CASE #PL2021-42

WALSER TOYOTA BLOOMINGTON, MN

Reviewed for Code Compliance
Date: 11/04/2022
By: K. Bayer
Plan # PRBD202210606

2022 NEW BUILDING FOR:
WALSER TOYOTA
4401 AMERICAN BLVD
BLOOMINGTON, MINNESOTA

EXTERIOR ELEVATIONS

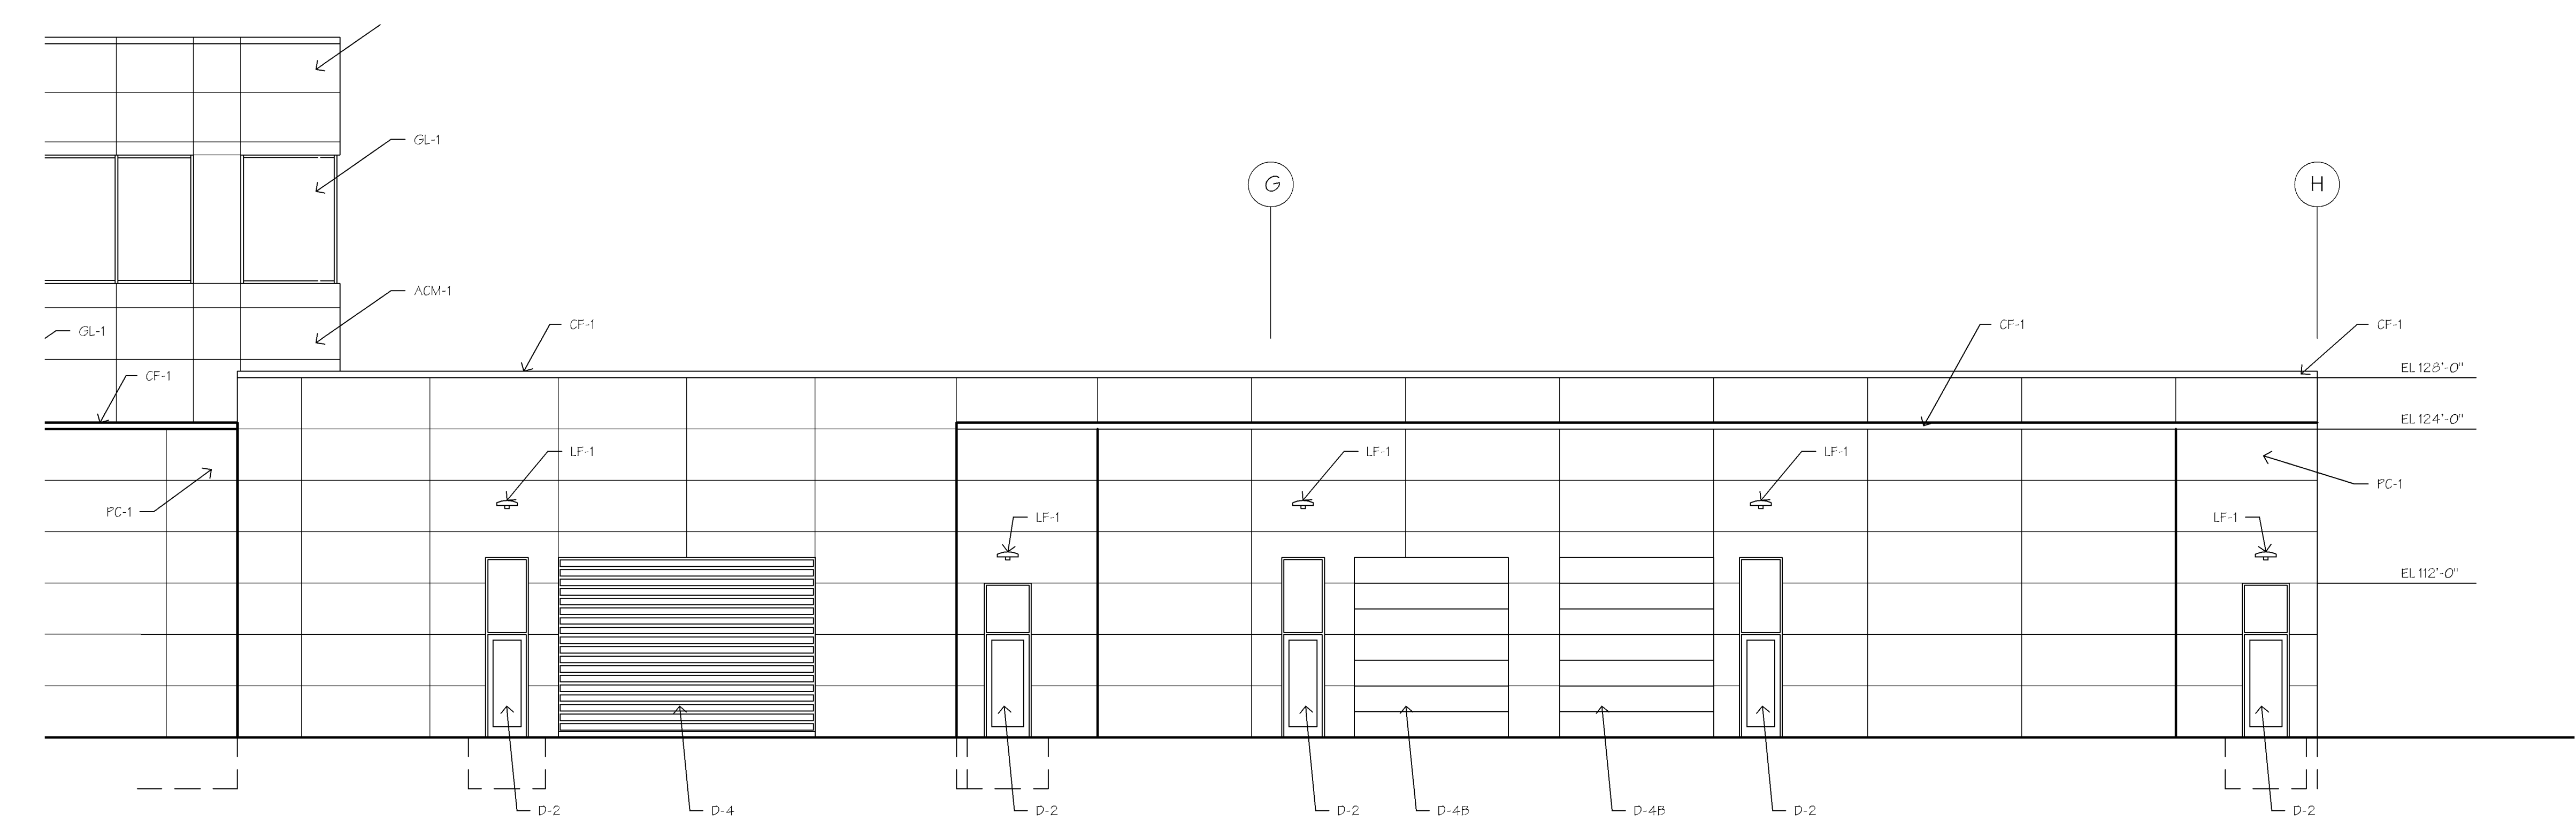
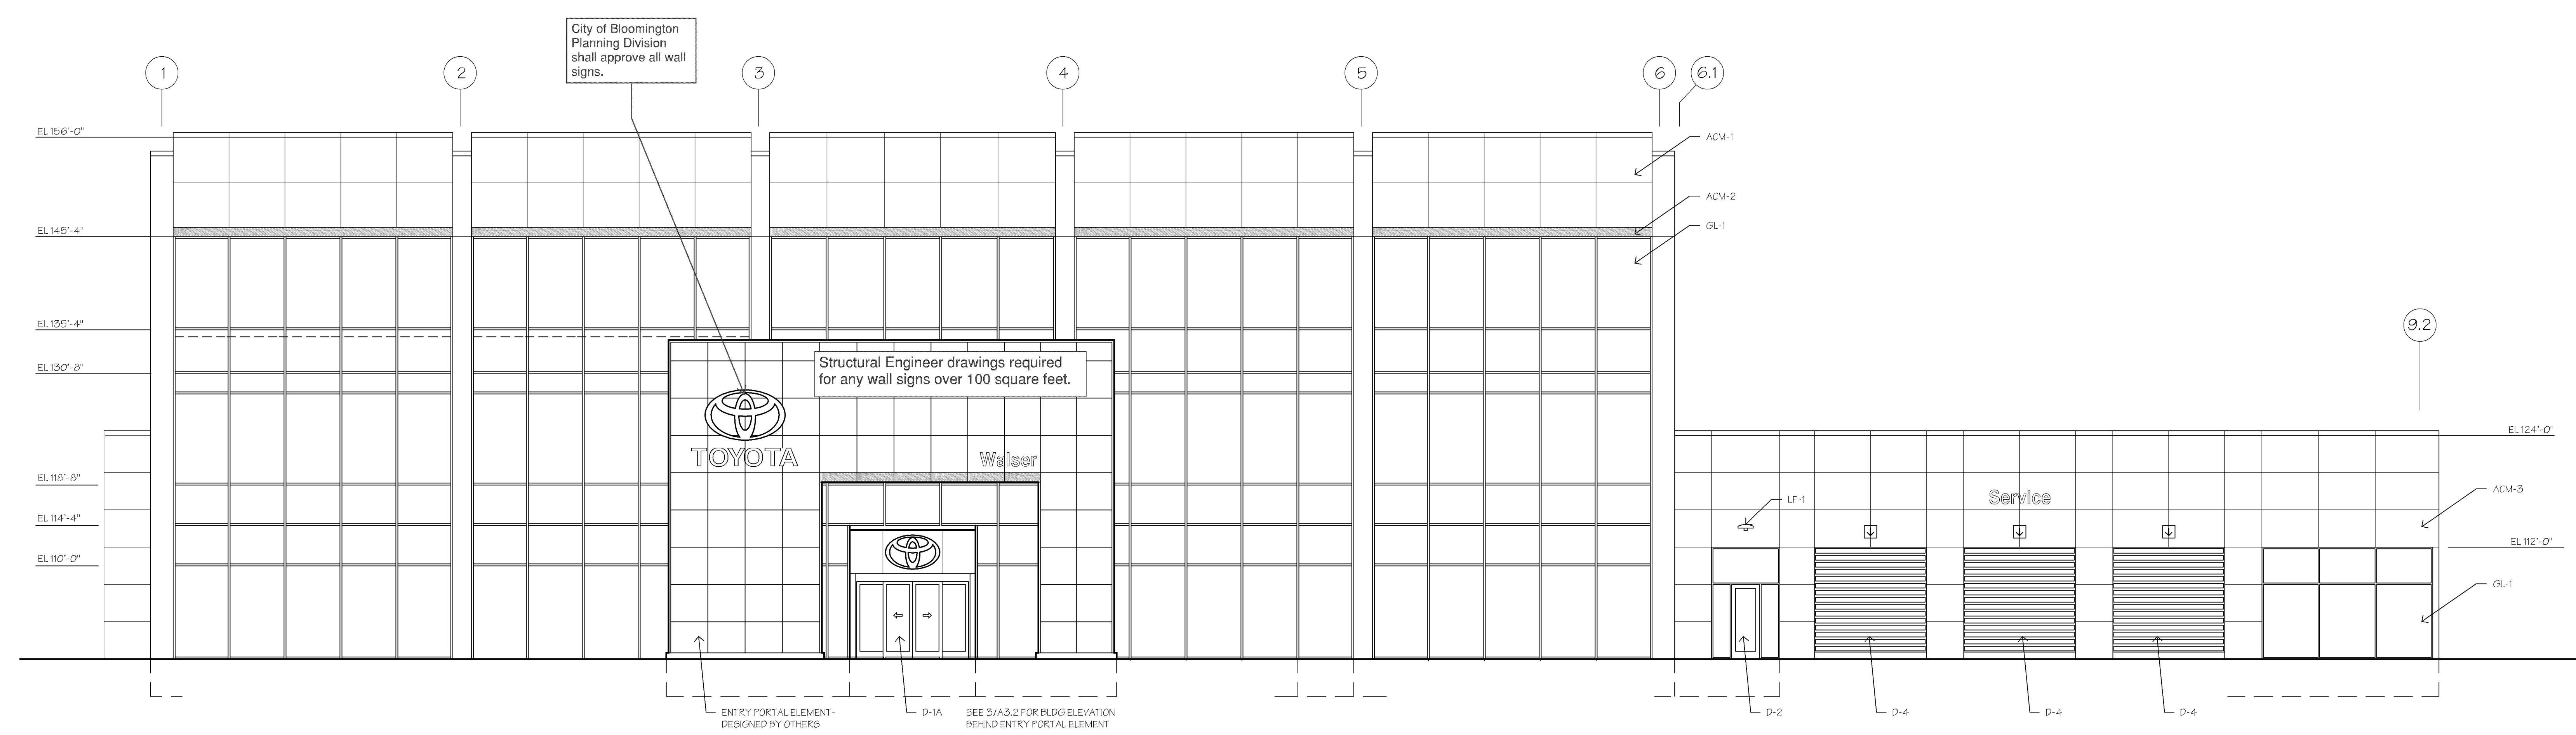
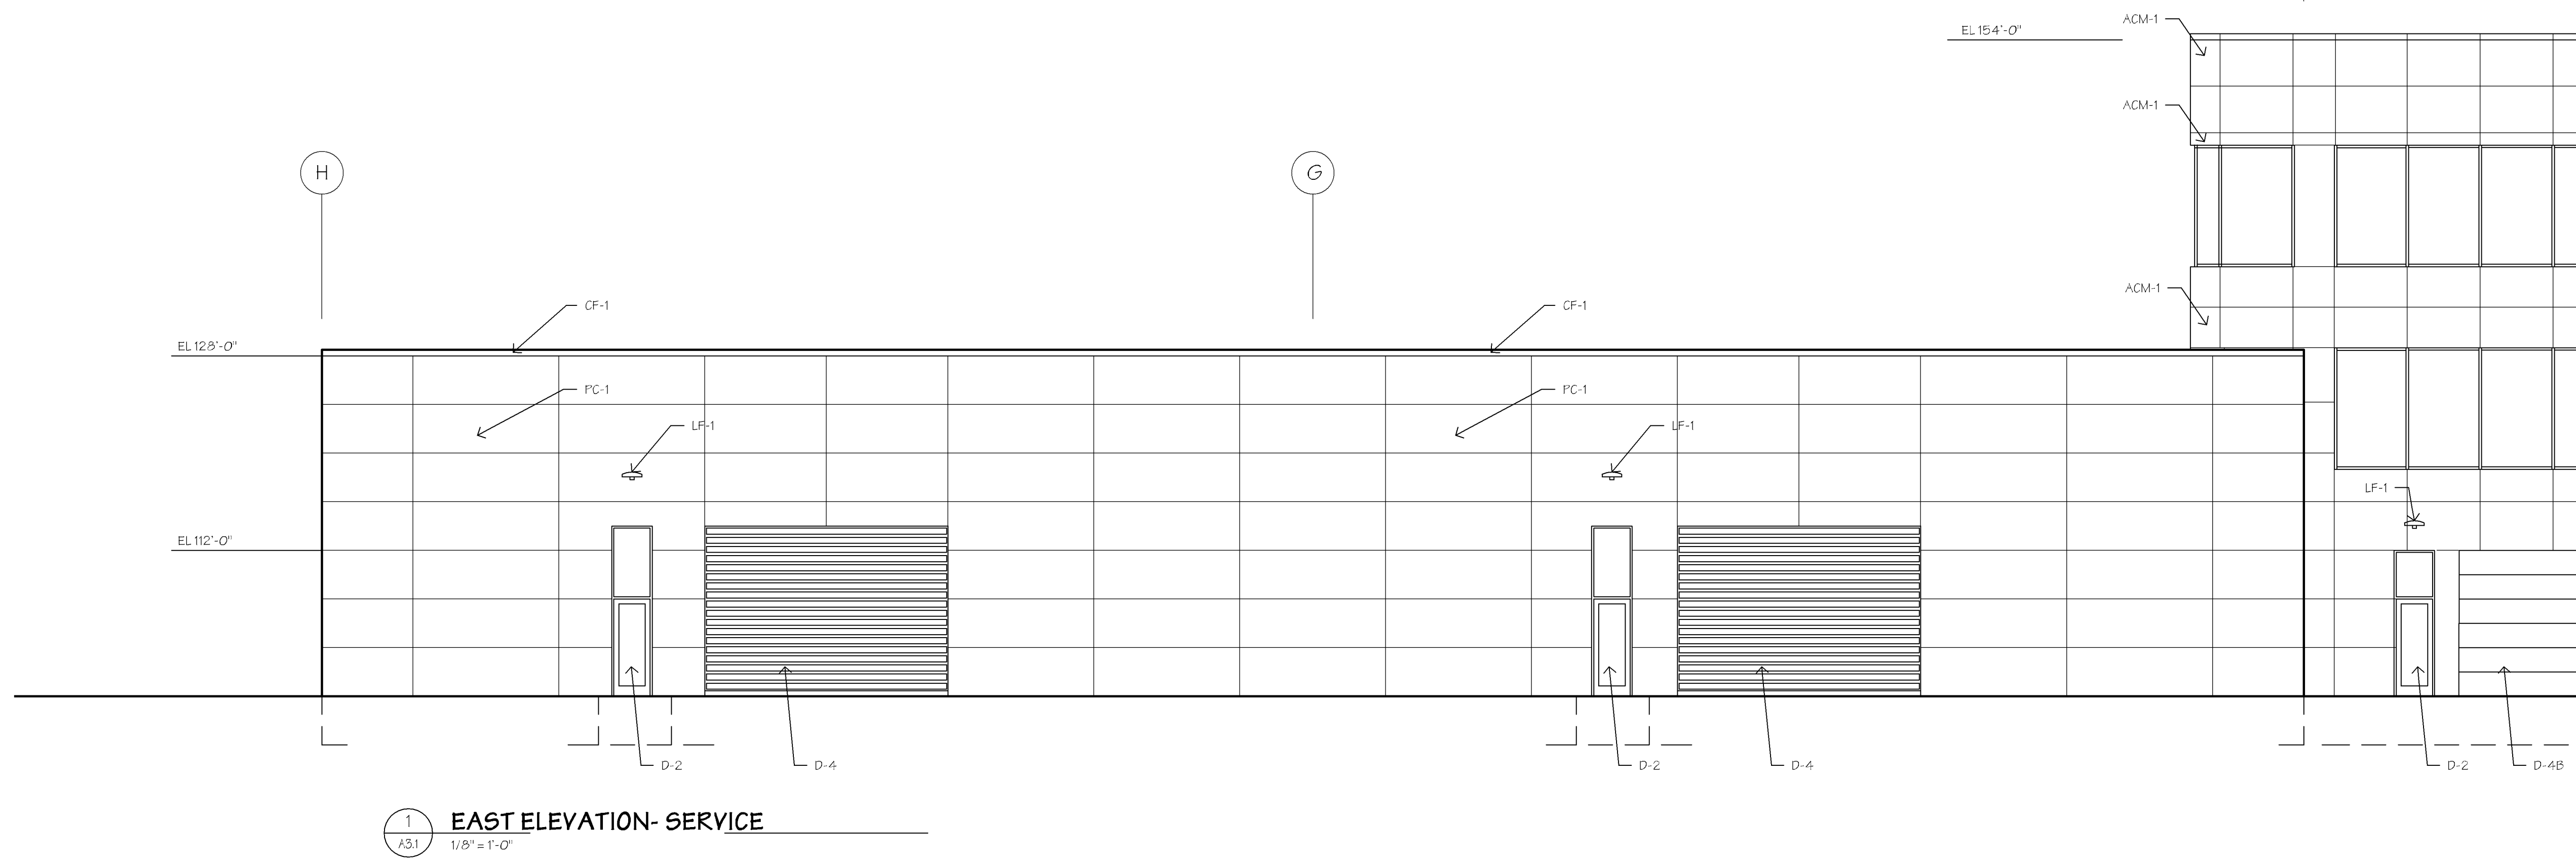
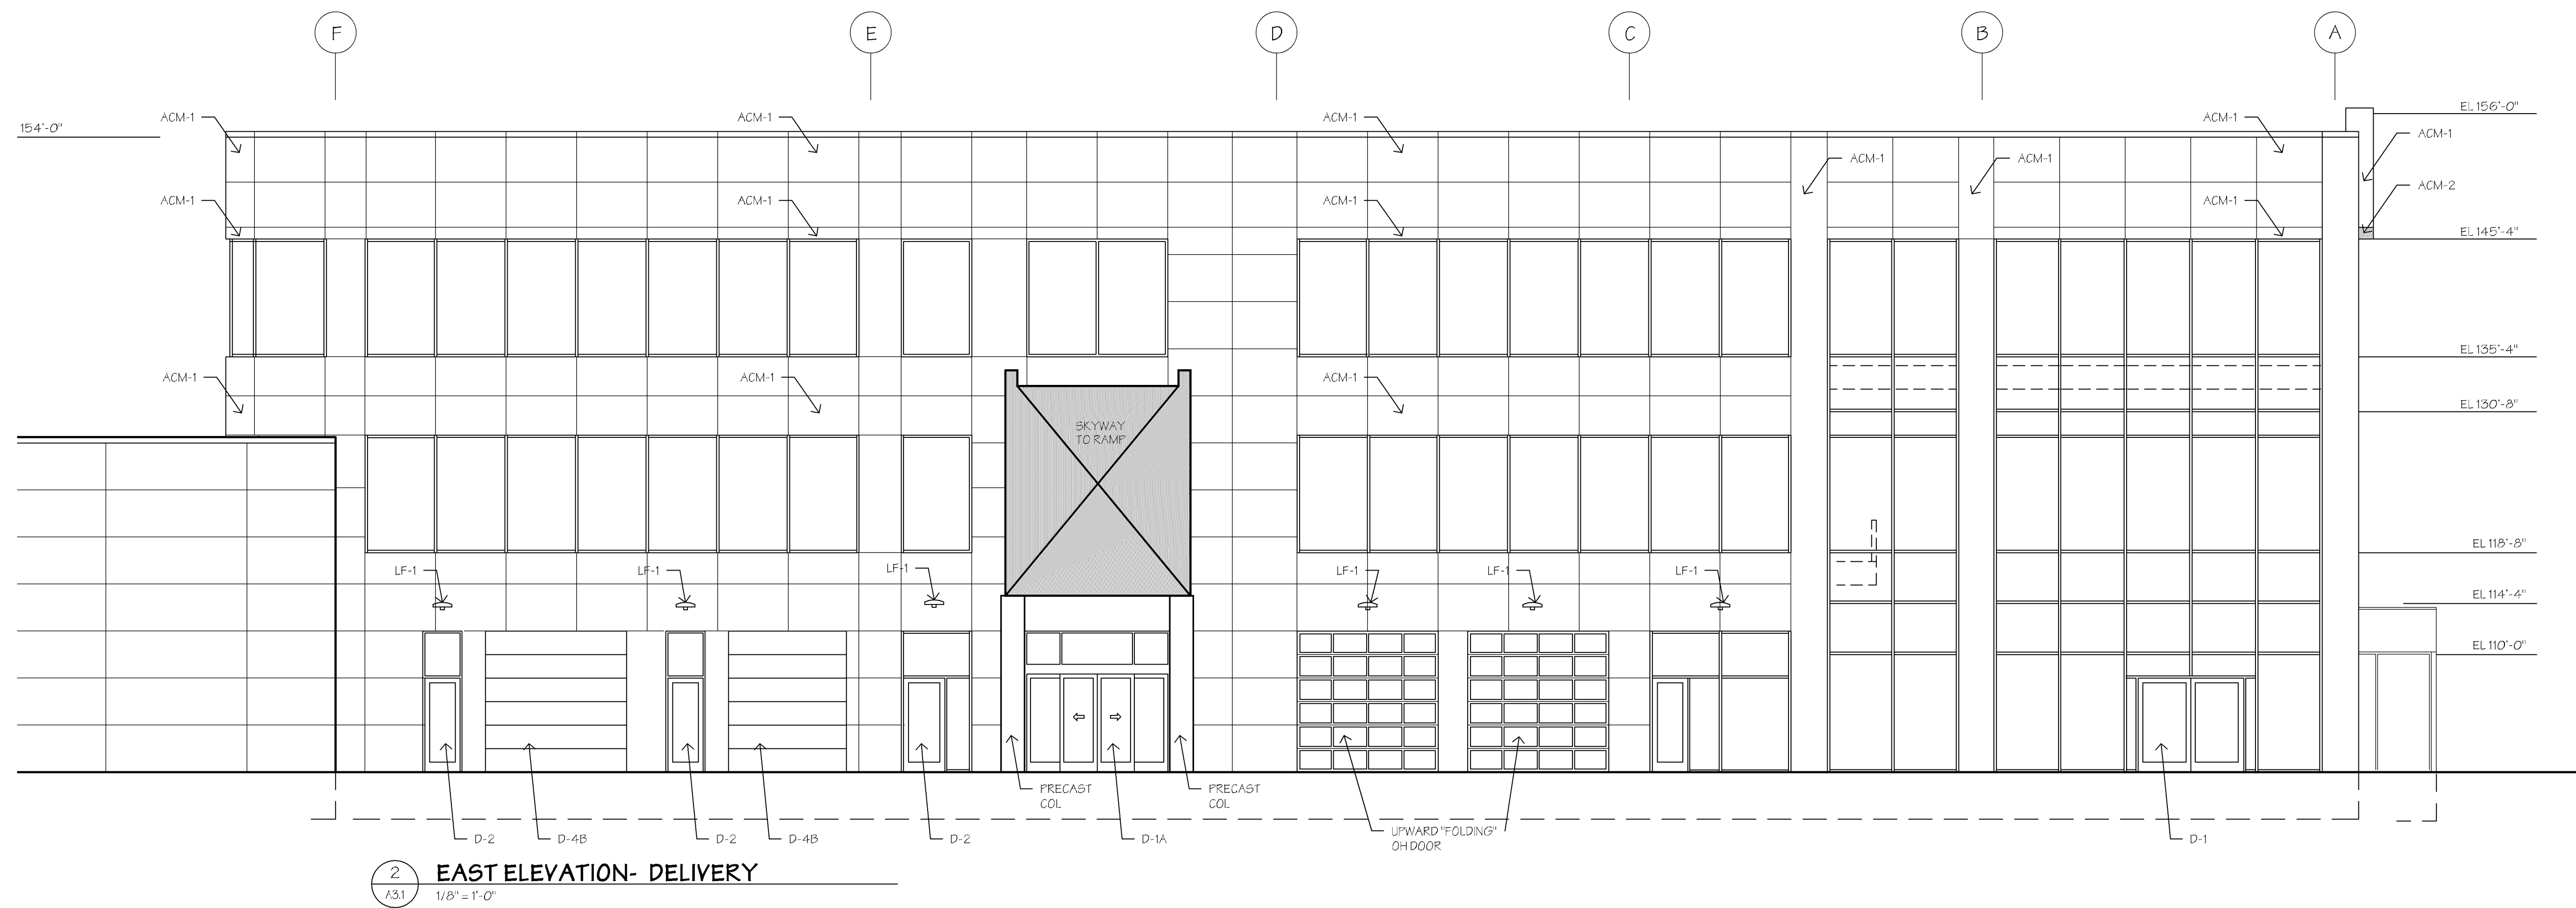
City of Bloomington Planning Division shall approve all wall signs.

Structural Engineer drawings required for any wall signs over 100 square feet.
